PERMIT

SEWAGE DISPOSAL SYSTEM

HOWARD COUNTY HEALTH DEPARTMENT

SUBDIVISION Choi Property LOT 20 ROAD 3348 Danmark Drive

PLAN TO ACCOMMODATE
 FOR BUILDING
 CHOI PA
 LOT

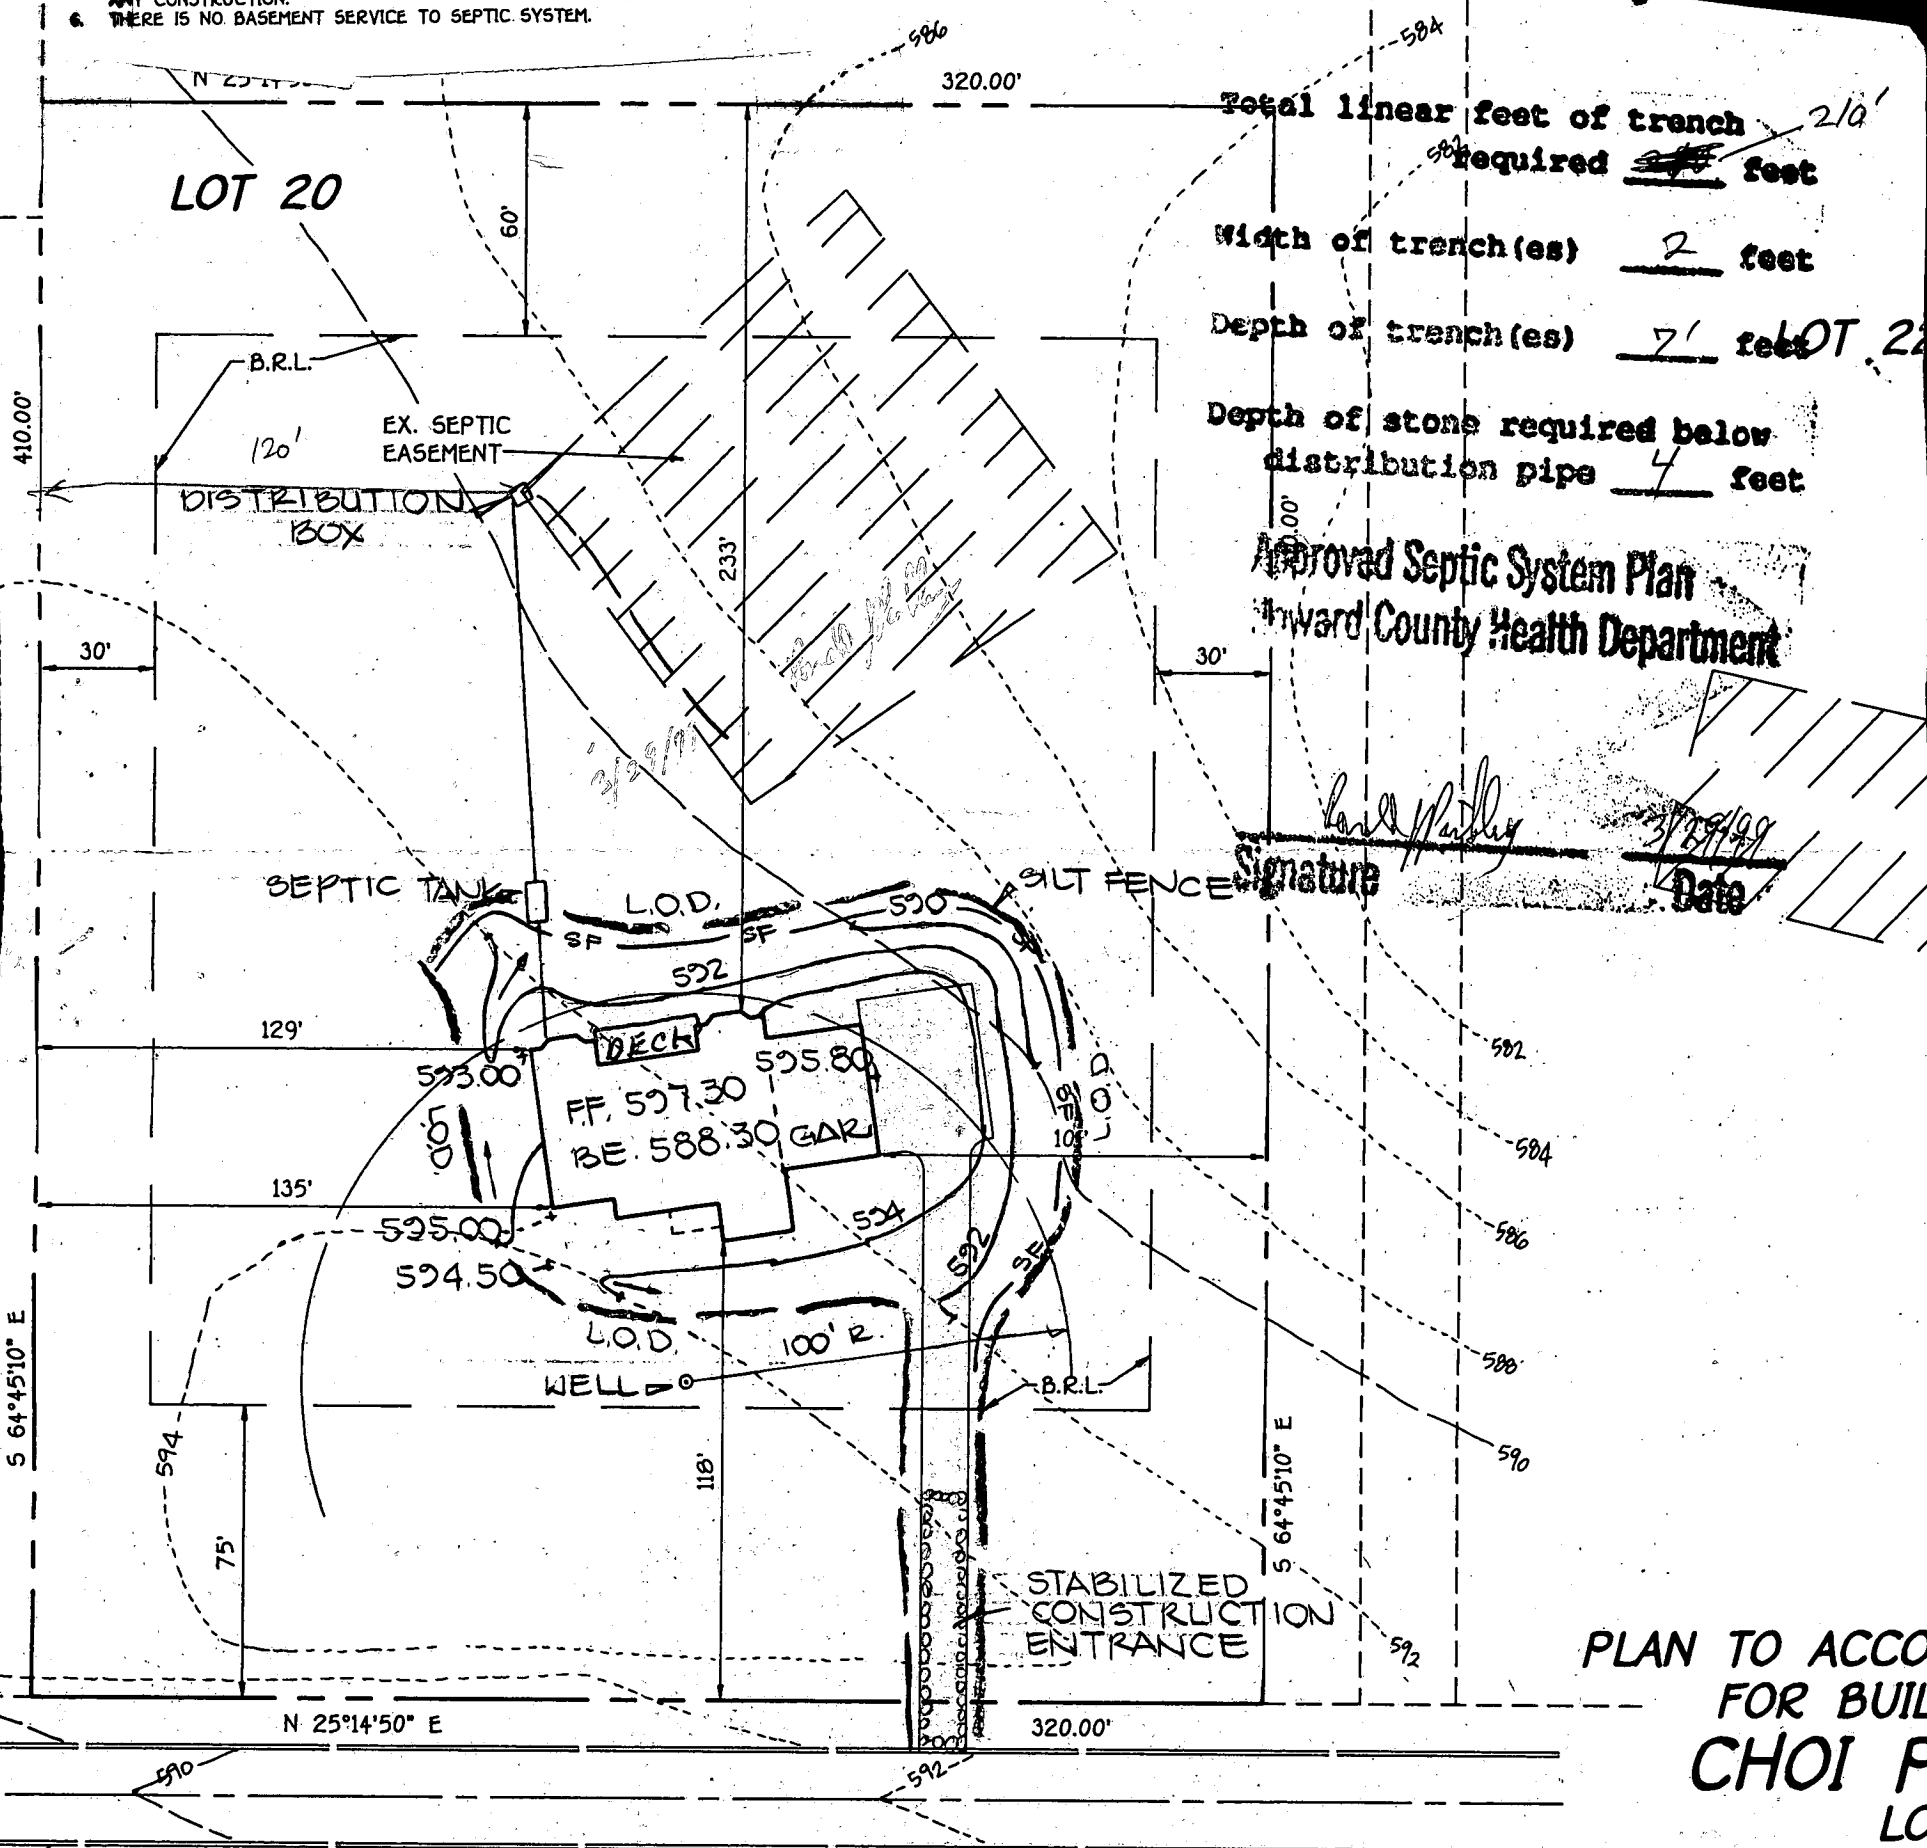
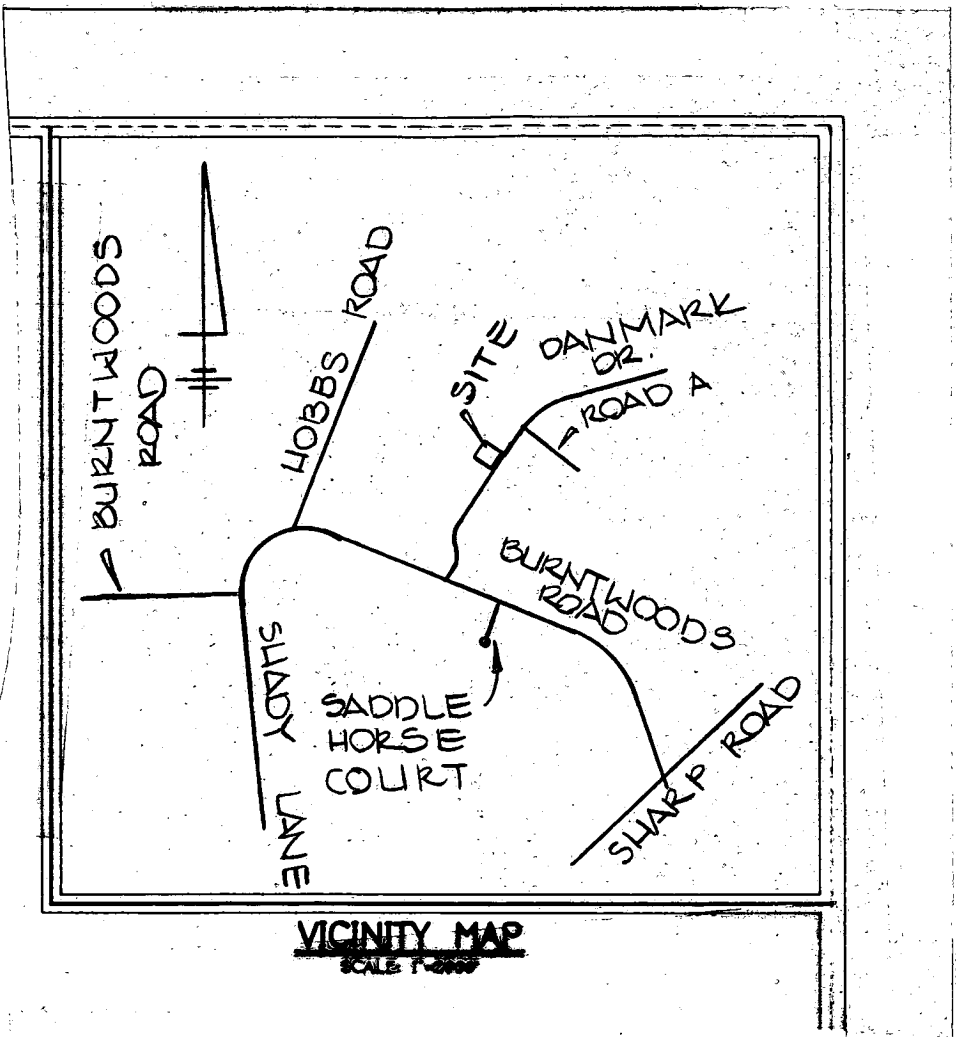
Total linear feet of trench required 210' feet
 Width of trench(es) 2 feet
 Depth of trench(es) 7' feet
 Depth of stone required below distribution pipe 4 feet

Approved Septic System Plan
 Howard County Health Department

HOUSE LOCATION
DRAWING

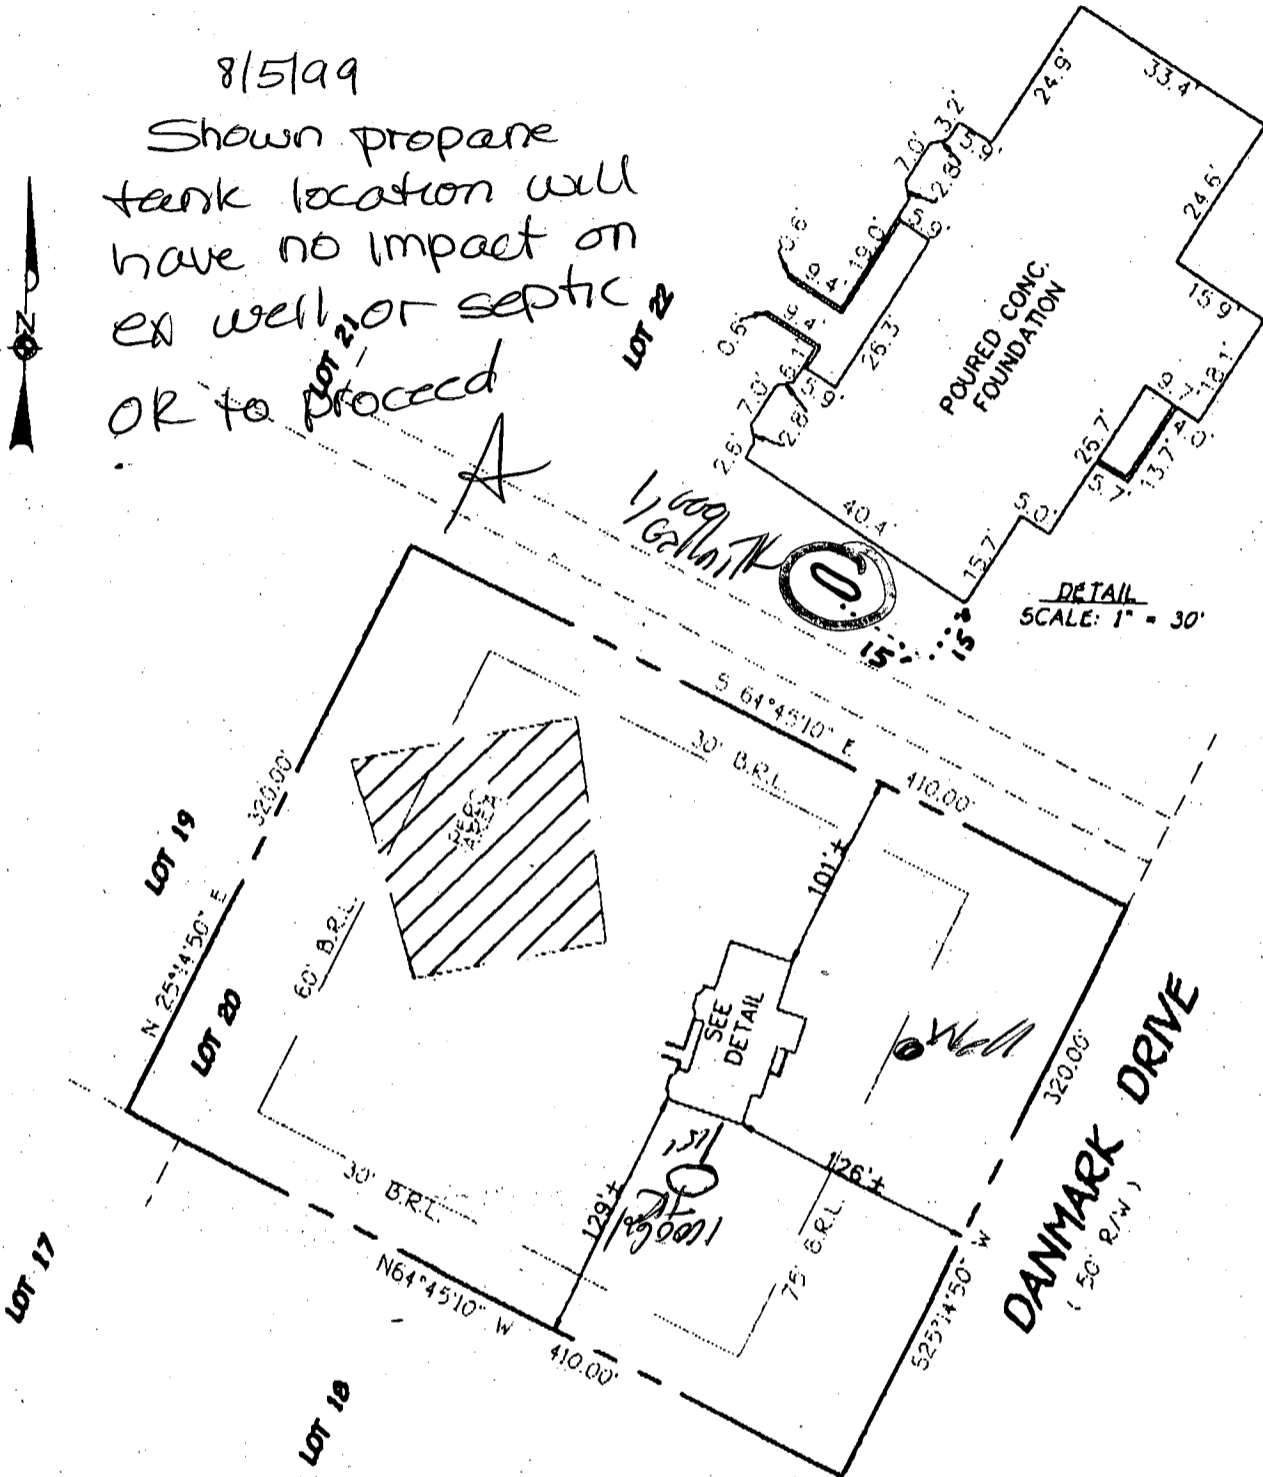
Shown propane tank location will have no impact on ex well or septic OR to proceed

**HOUSE LOCATION
DRAWING**

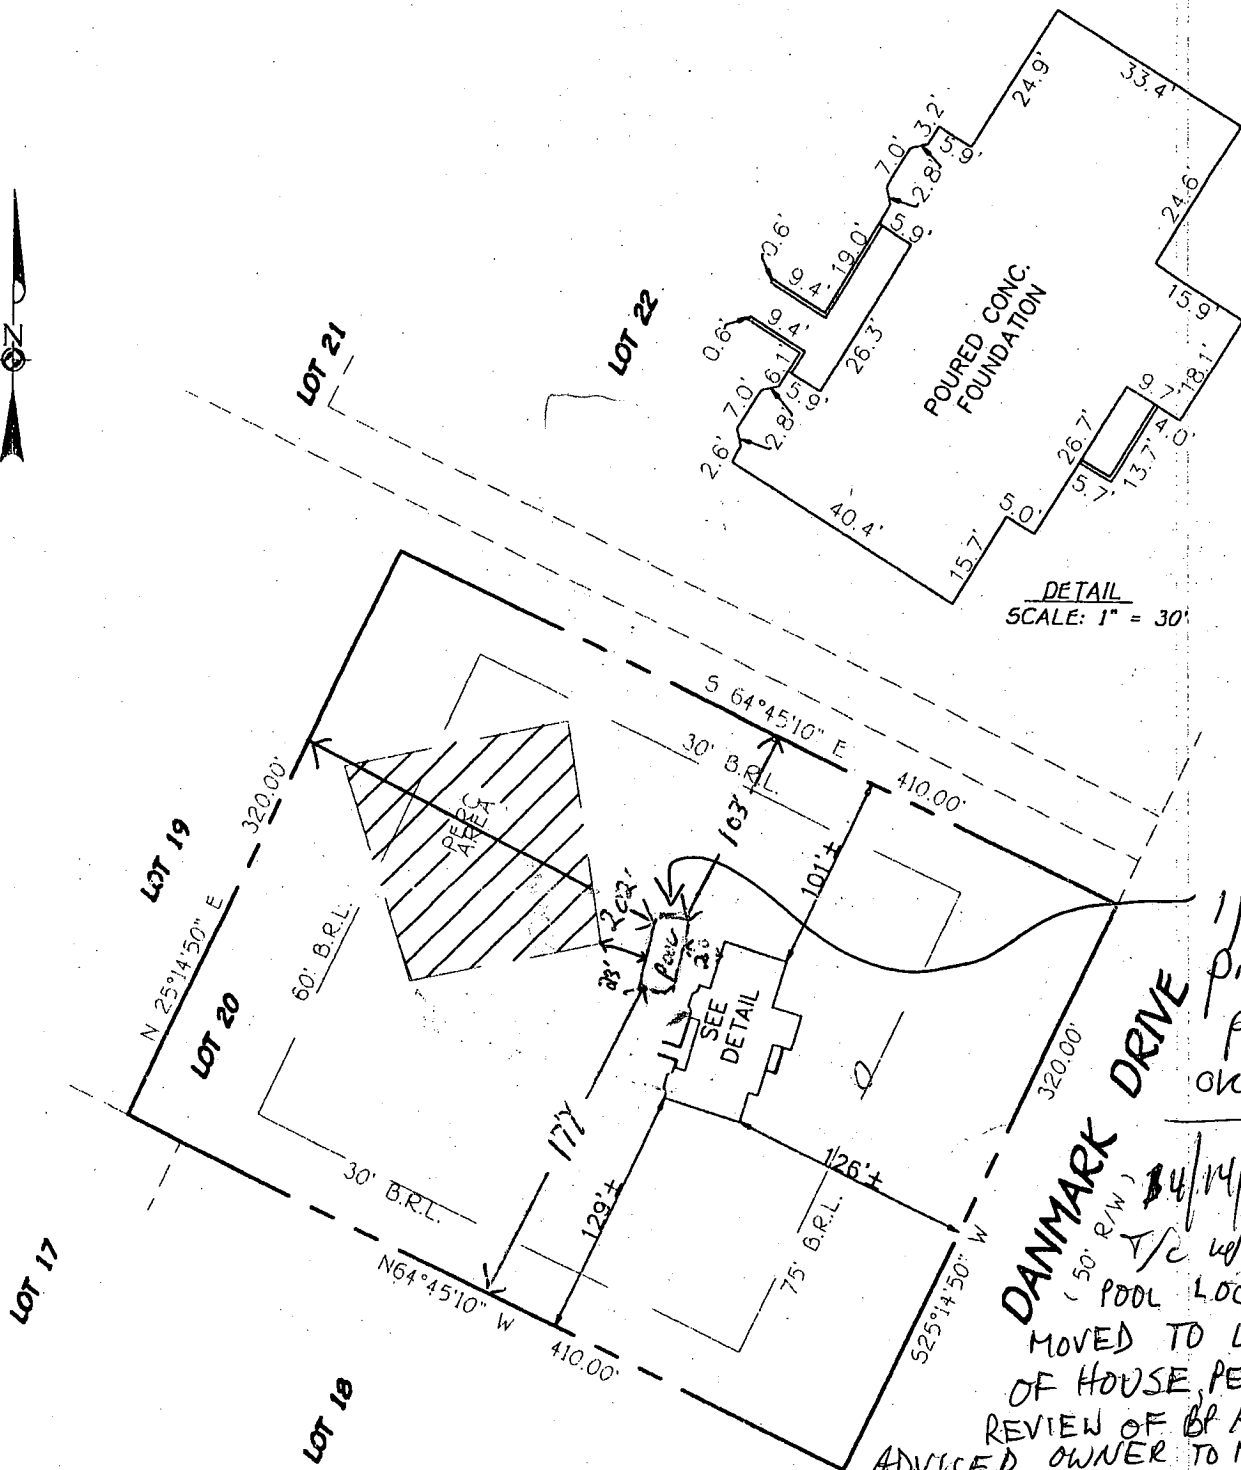
1/8/03
Proposed
pool
OK SRV

34/14/03 (MP)
T/C w/ OWNER:
POOL LOC TO BE
MOVED TO LEFT SIDE
OF HOUSE, PENDING
REVIEW OF BP AMENDMENT.
ADVISED OWNER TO MAINTAIN

HOUSE LOCATION DRAWING

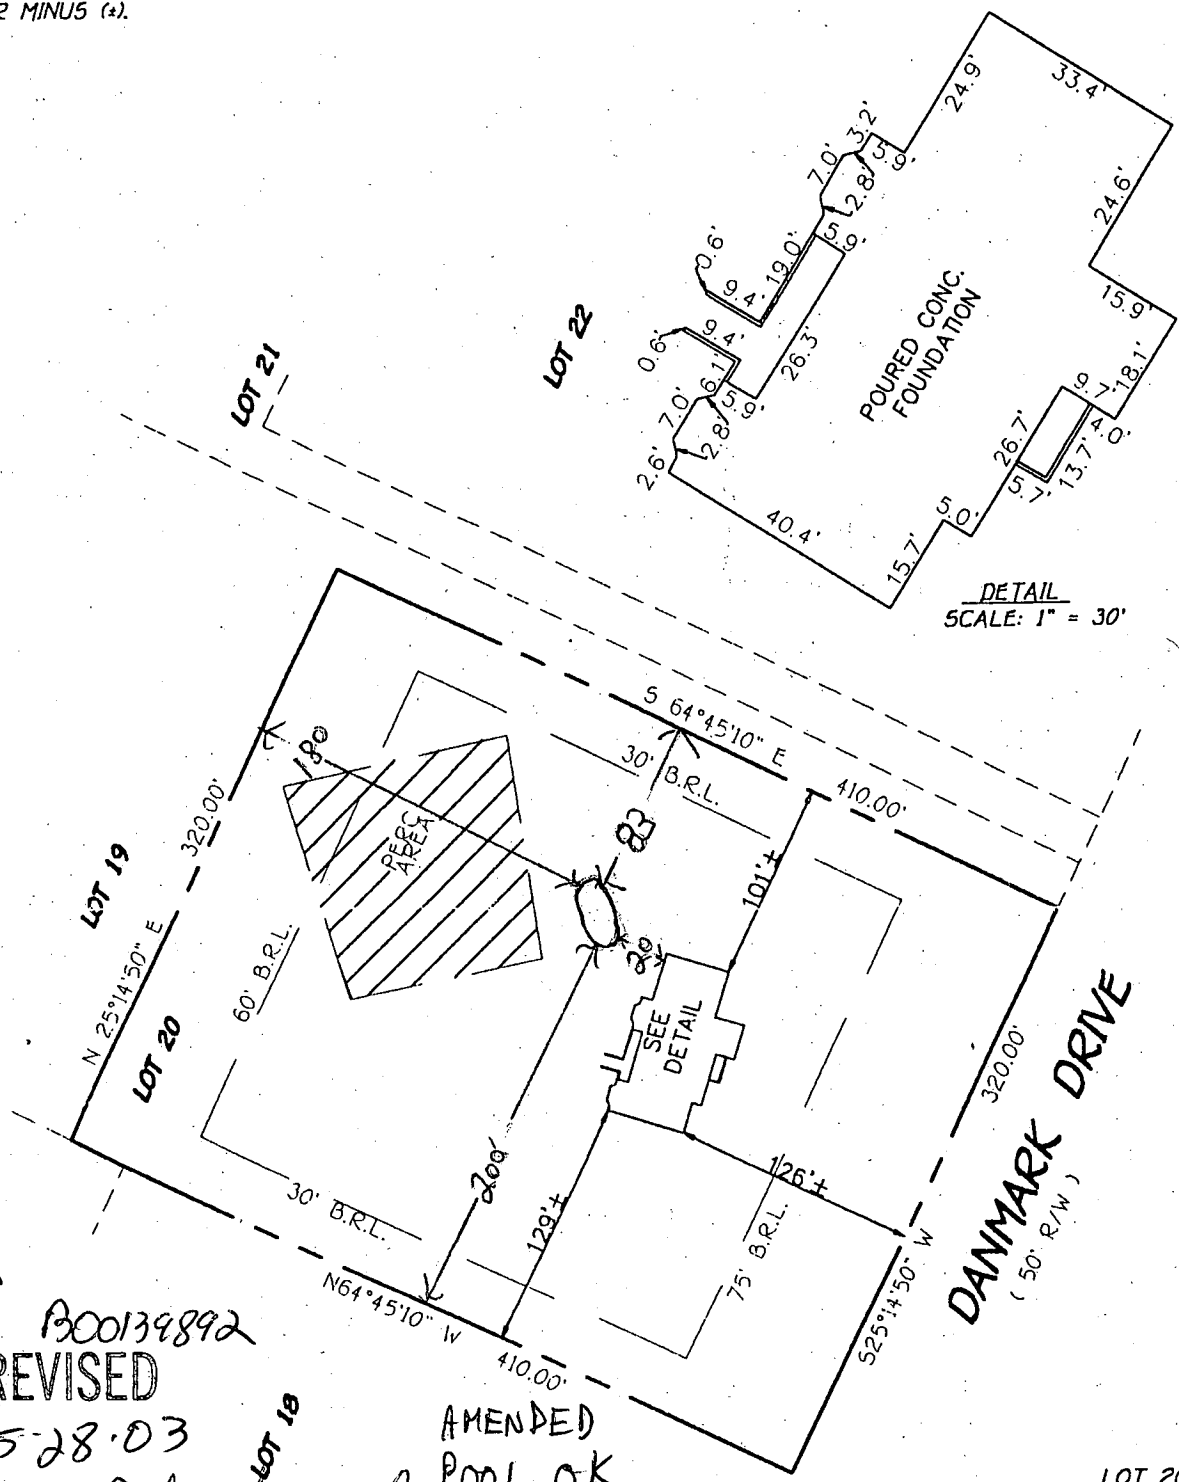
LOT 17
B000139892
REVISED
Date: 5-28-03
Comments: Relocate pool

AMENDED
POOL OK
MR 7/3/03
